NOTICE OF OPEN MEETING
AGENDA
PLANNING AND ZONING COMMISSION
City of Moberly
City Council Chambers – Moberly City Hall
101 West Reed Street
May 30, 2023
6:00 PM

Subject: Zoning Applications 1120 S Morley St

Subject: *Site Plan Review Application 1225 Aviator Lane*

Conceptual Site Plan for 1120 South Morley Street

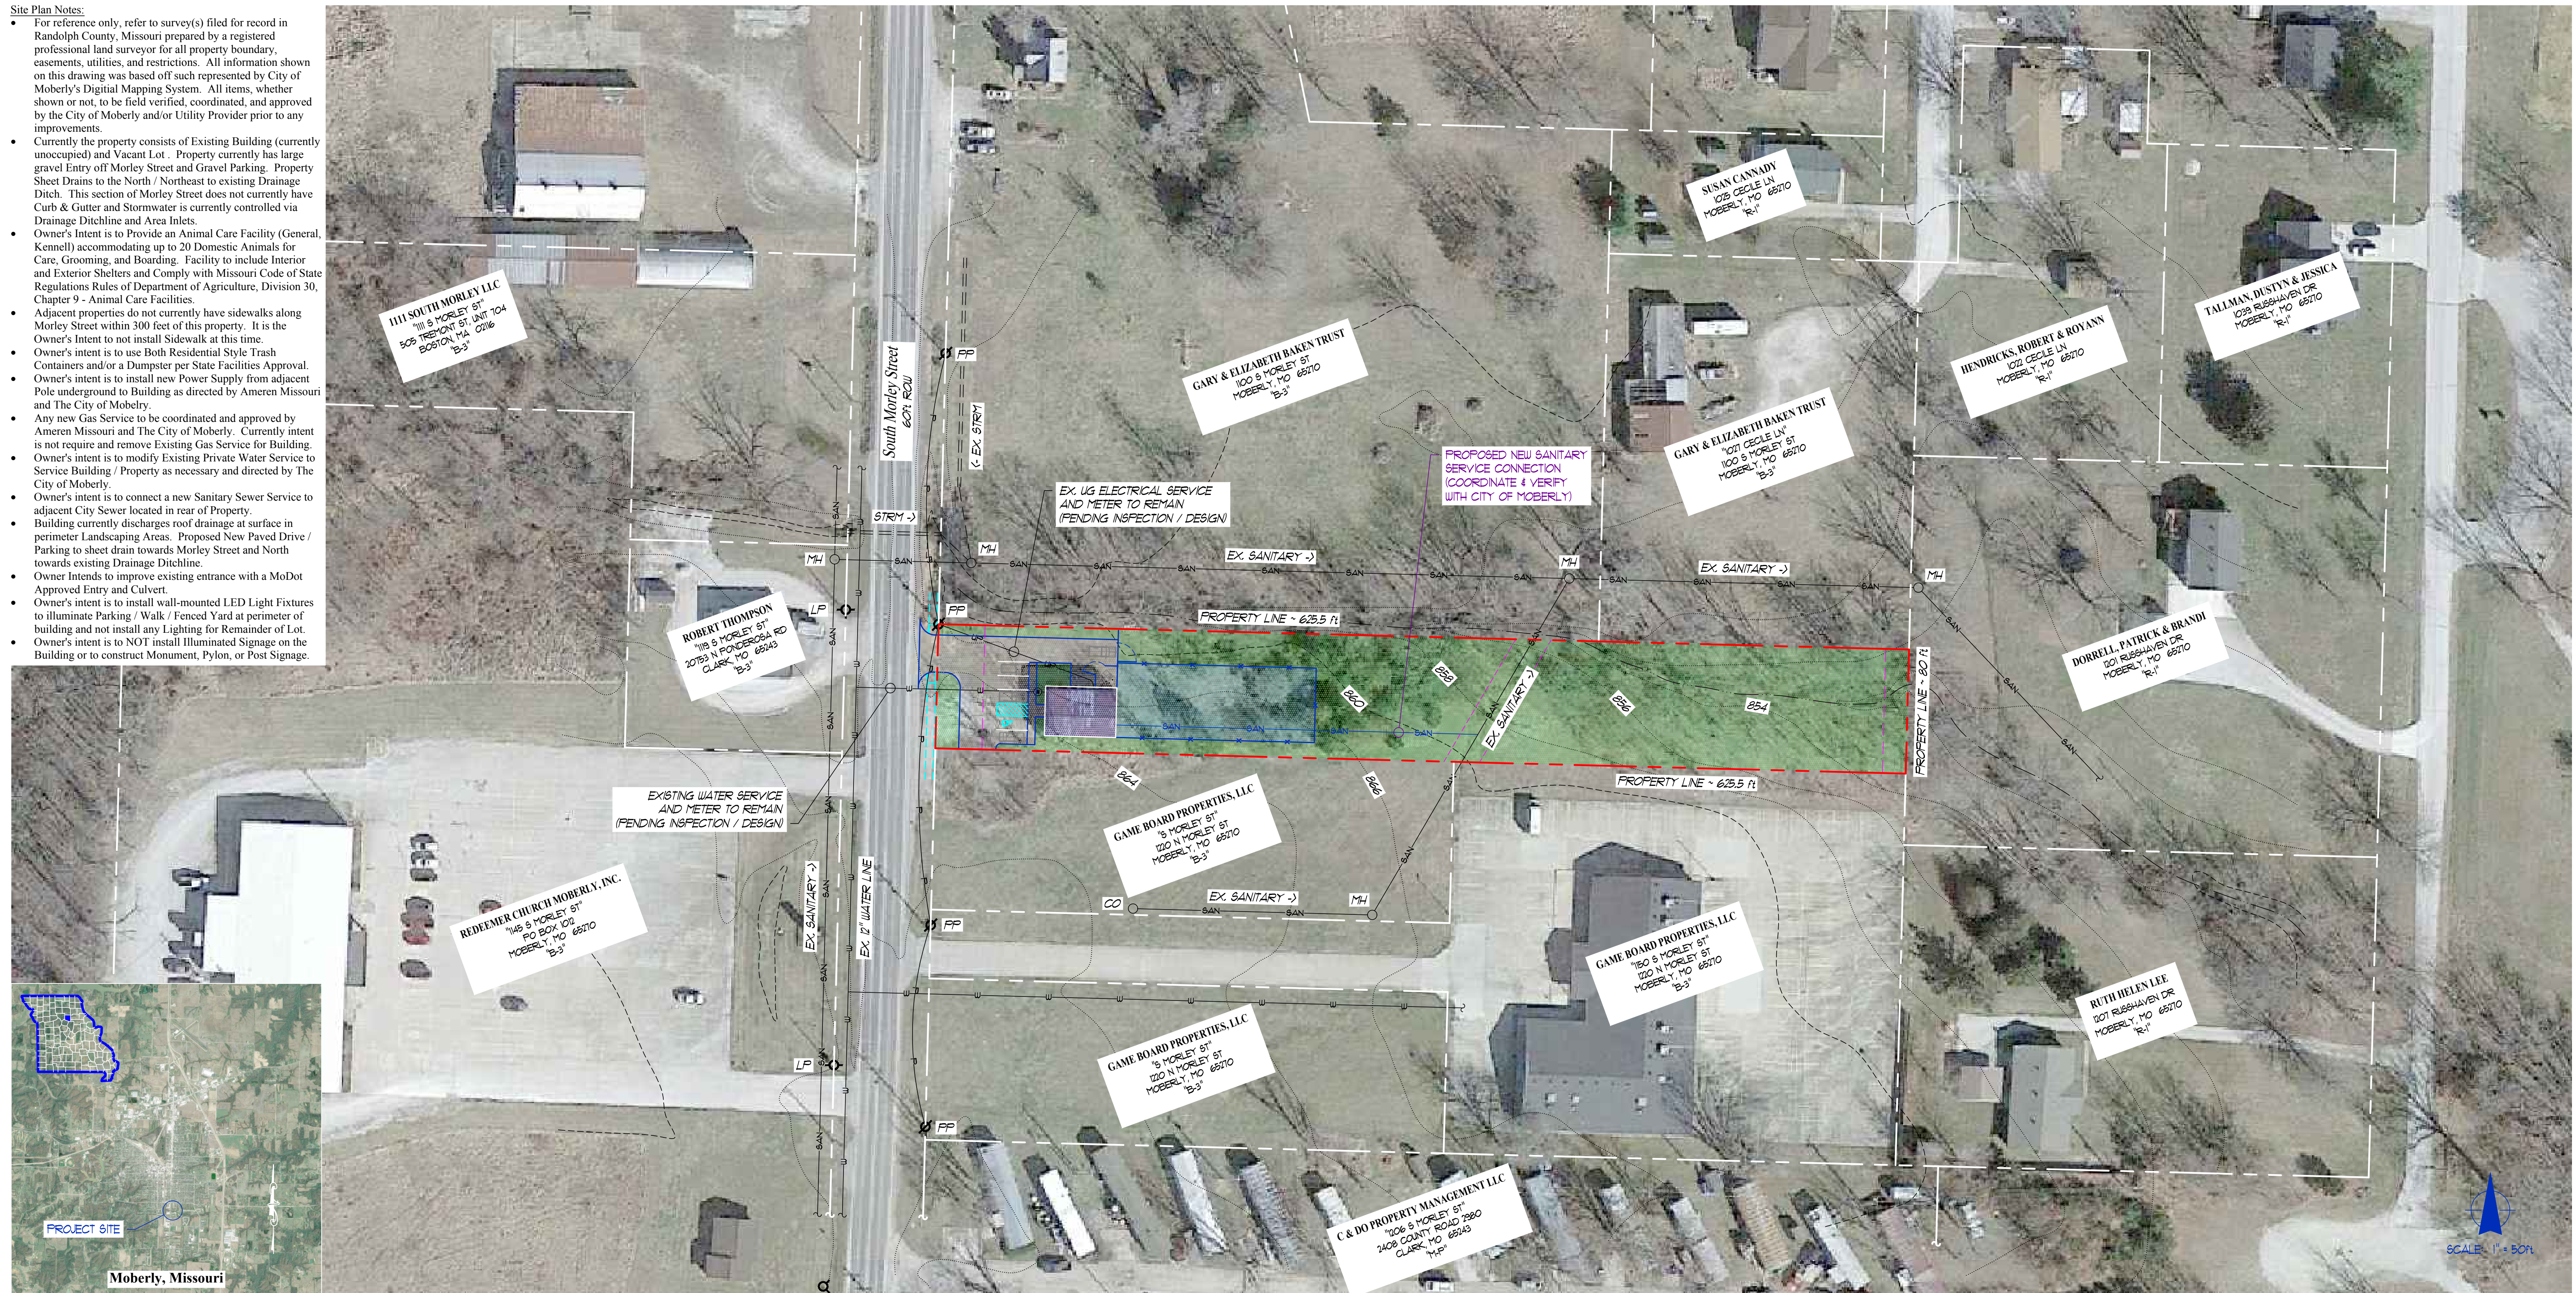
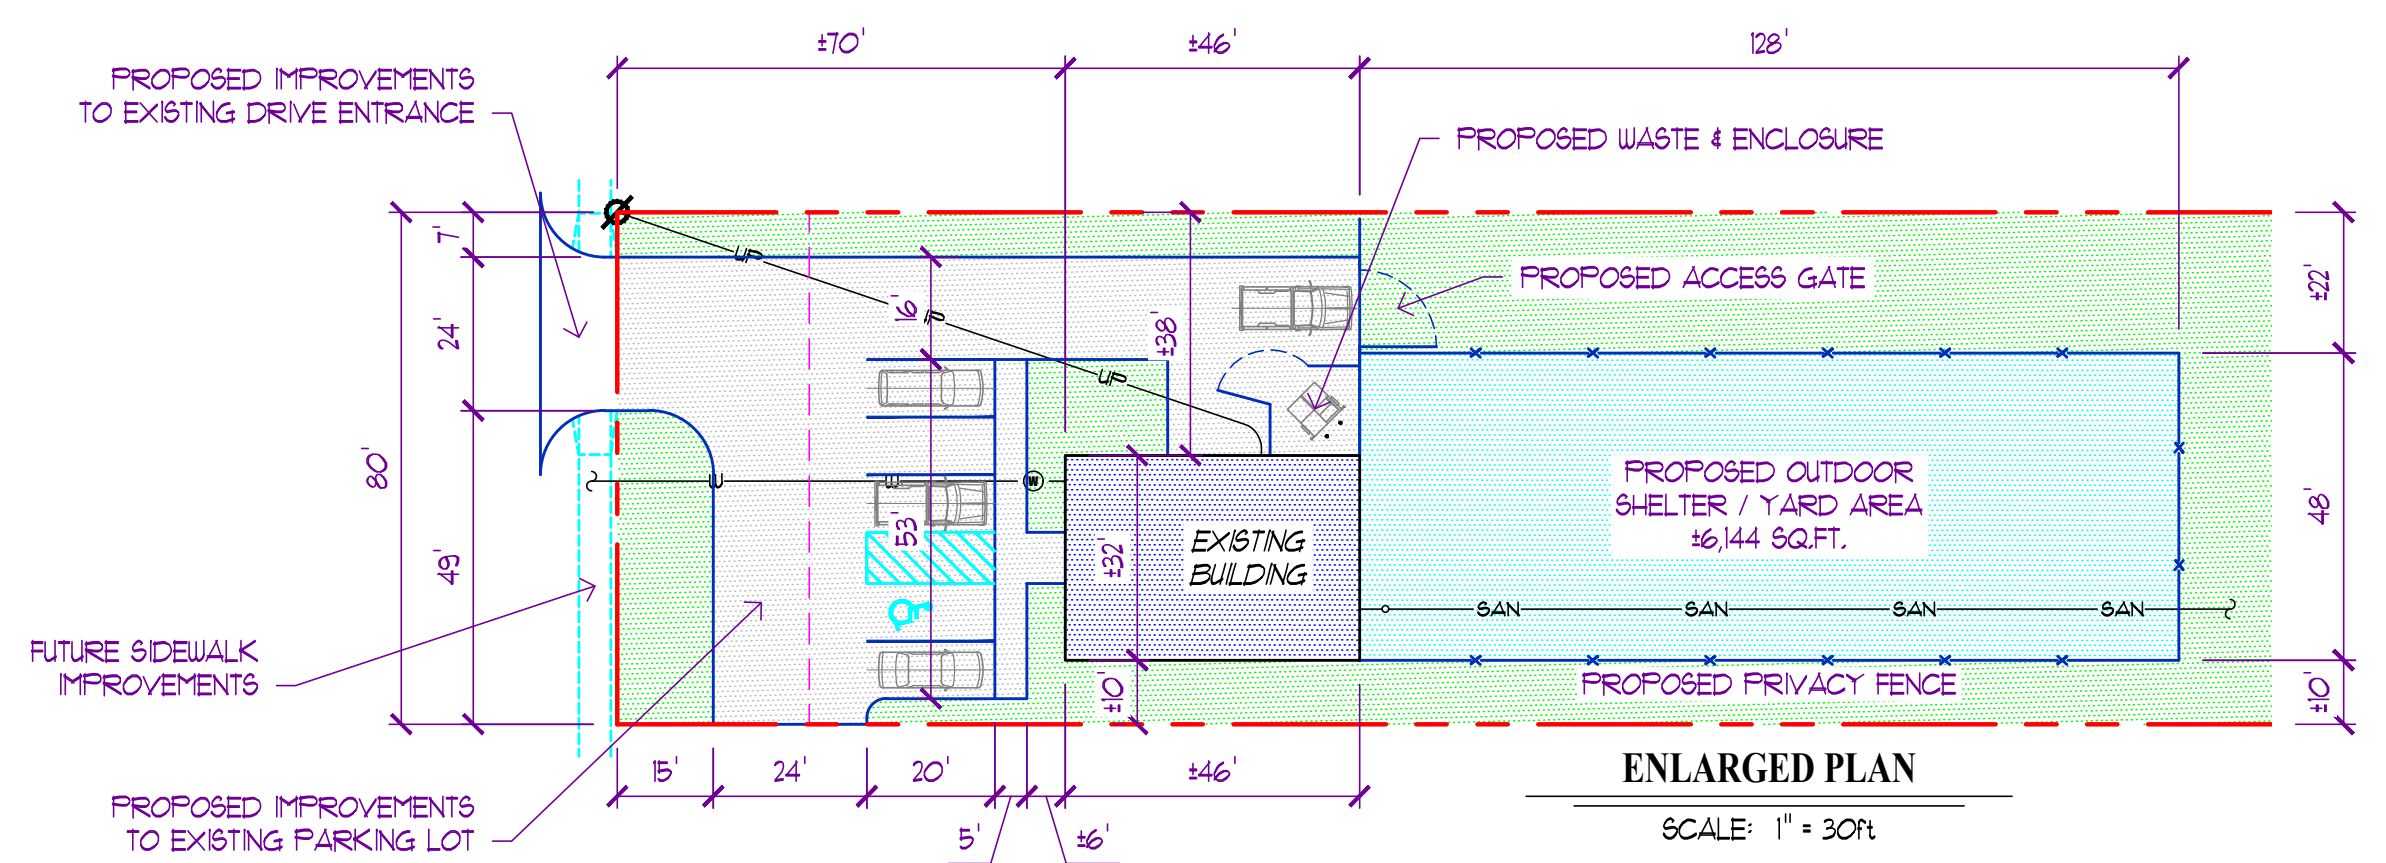
Public areas: (46-177) Parking - Adequate Spaces and ingress and egress are provided in the drawing.; (36-132) Sidewalks – City Designee requests sidewalks be installed, Owner request exemption to sidewalks as no existing sidewalks in area to connect to on either side of the public road

Staff review does not require any additional changes to the landscaping, parking, screening, and layout of the site. Discussion of the sidewalk did occur with no connectivity in the area, not future sidewalk plans for the next 10 years are currently planned for the site. Zoning Administrator requests that a “Cash in Lieu of” be submitted for the sidewalk installation.

- c. Are sidewalks at least 5 feet in width provided along all sides of a lot abutting a dedicated public or private street? No Public Sidewalks are intended for this Project at this time, however Proposed/Potential Future Improvements are indicated on the Conceptual Site Plan.*

Conceptual Site Plan for Edge Aviation Project

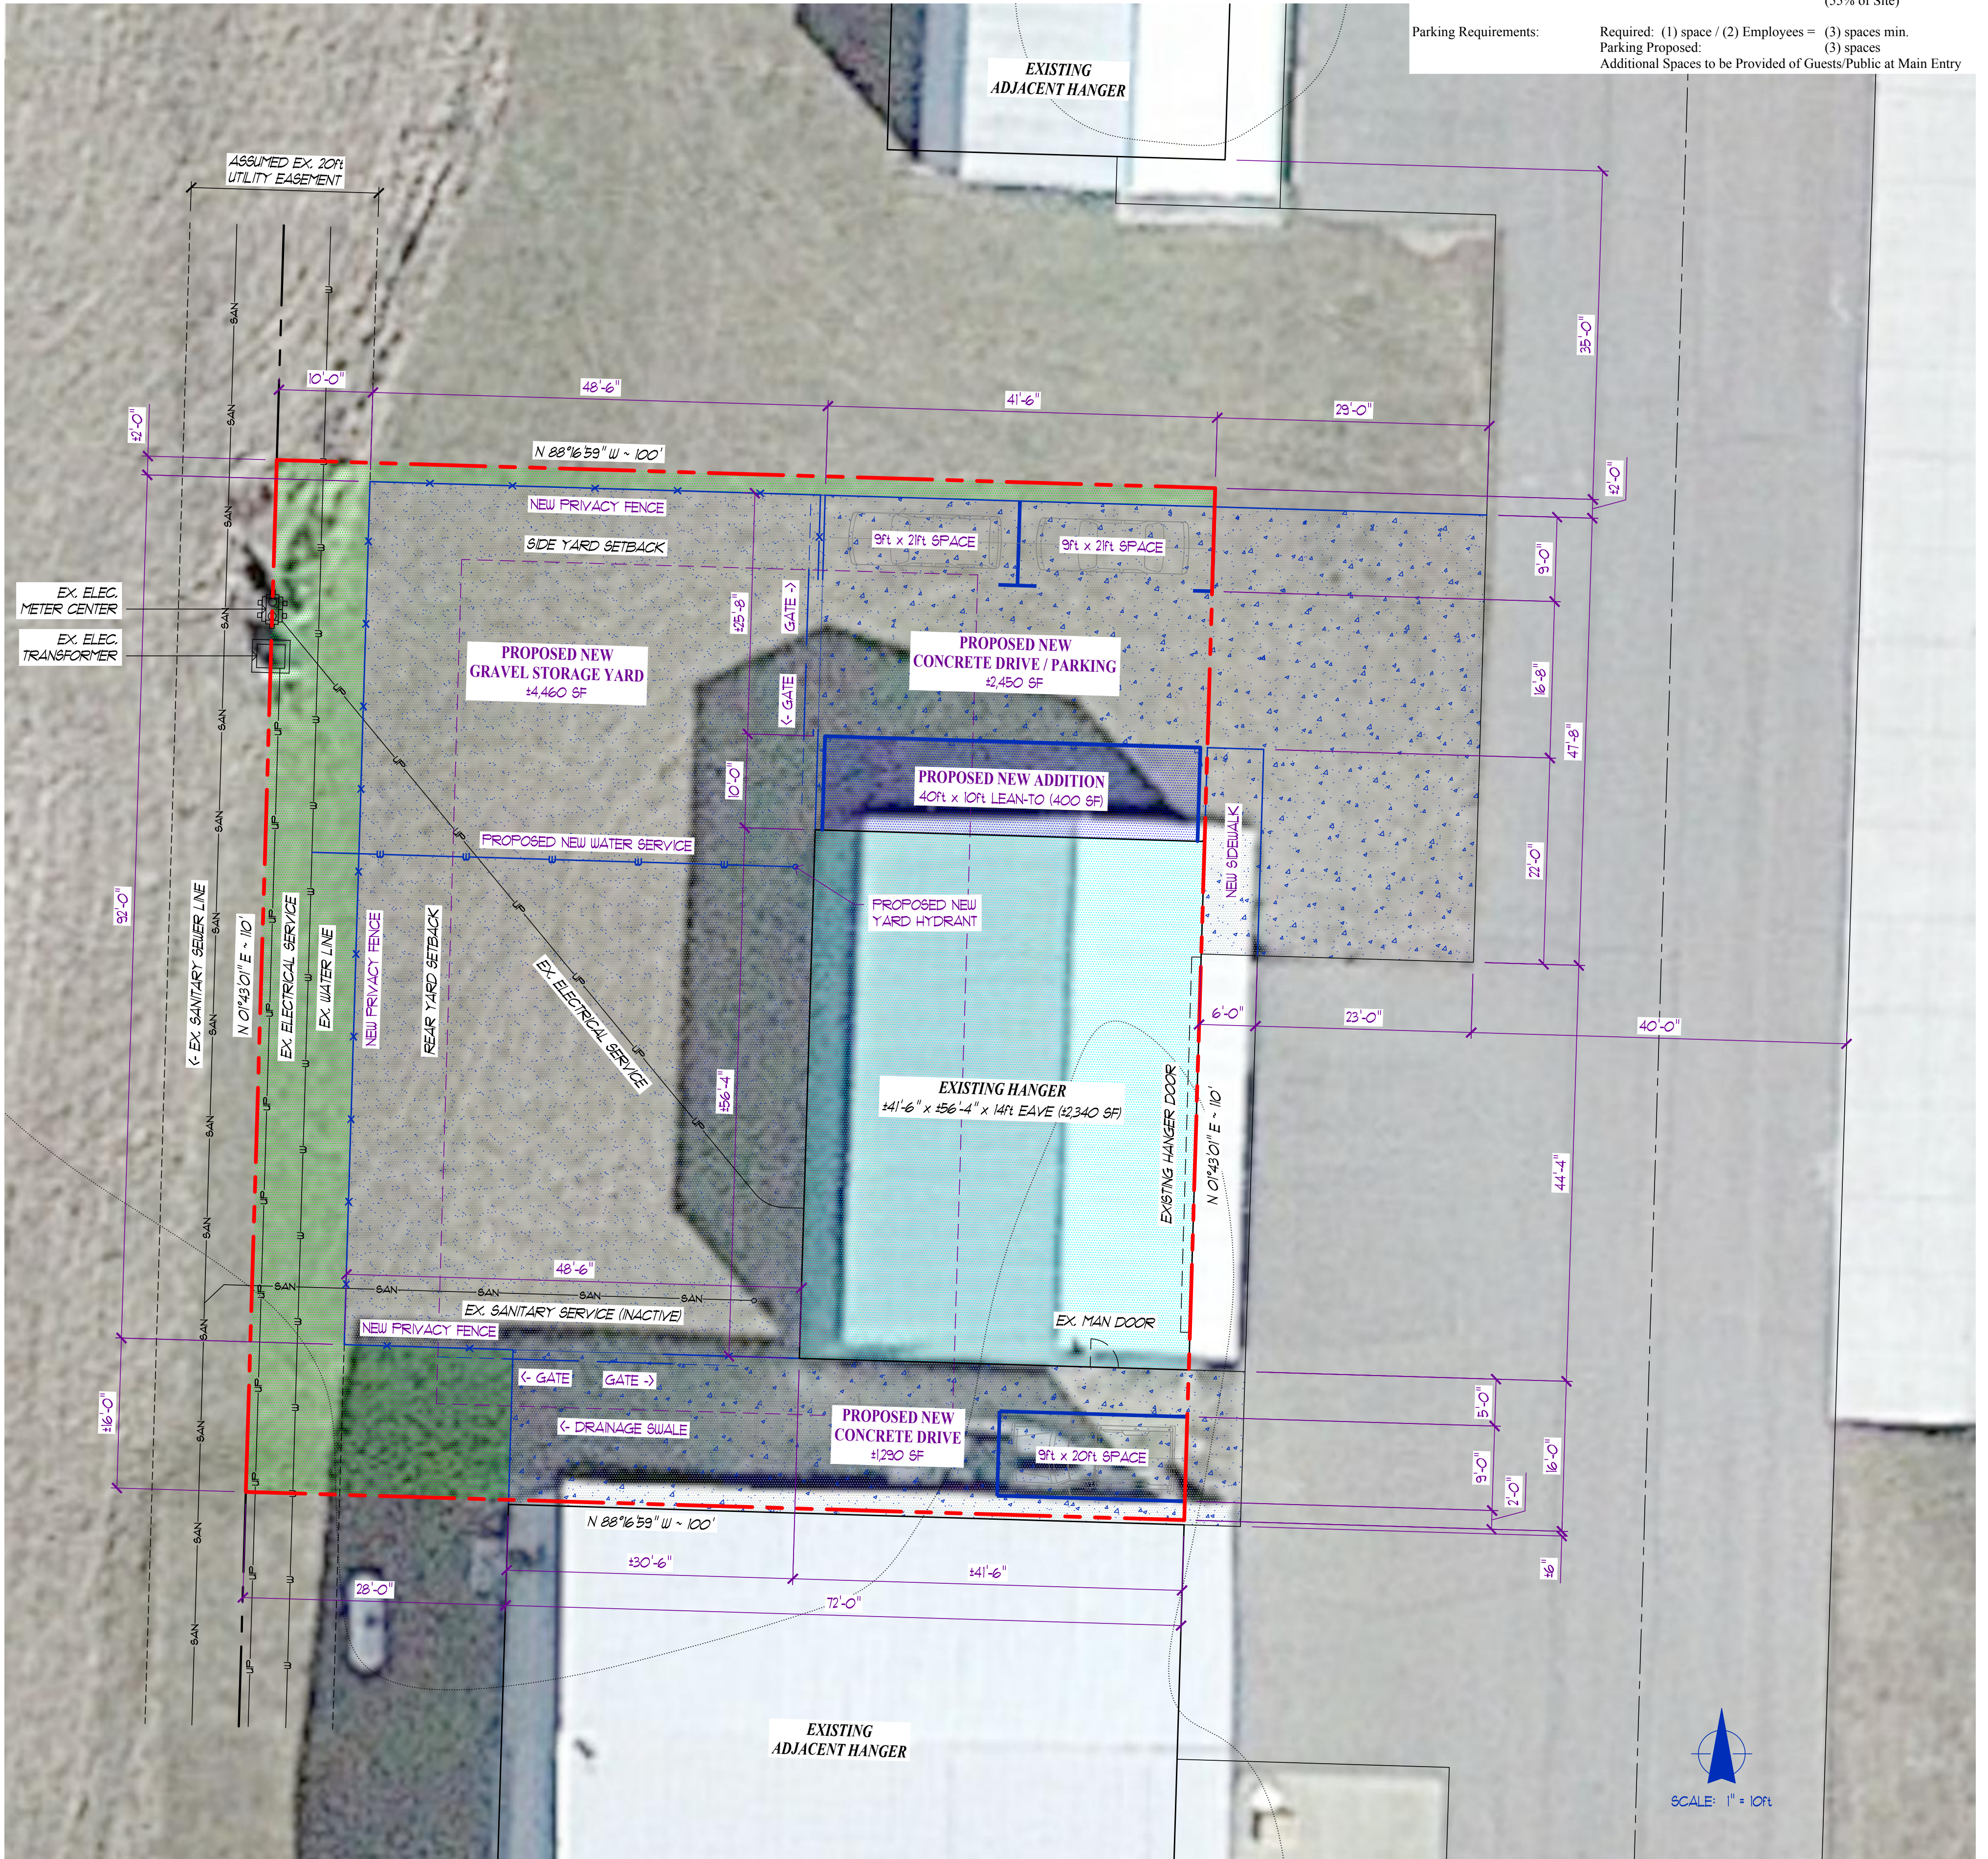
Staff Review has requested additional information on quantities, types, and depictions of where on the property the storage of business related supplies will be within the perimeter of the site plan boundary.

It is the intent to Improve/Pave Existing Gravel Drive/Parking Areas and New Apron, Drive, and Parking Areas connecting a proposed +/-4,500 sf Gravel Storage Yard in Rear of Building with Perimeter Privacy / Security Fencing. Remaining Green Spaces as indicated on the Conceptual Site Plan to consist of Grass & Trees and/or Required Landscaping Drainage Areas consisting of at least 50% living materials.
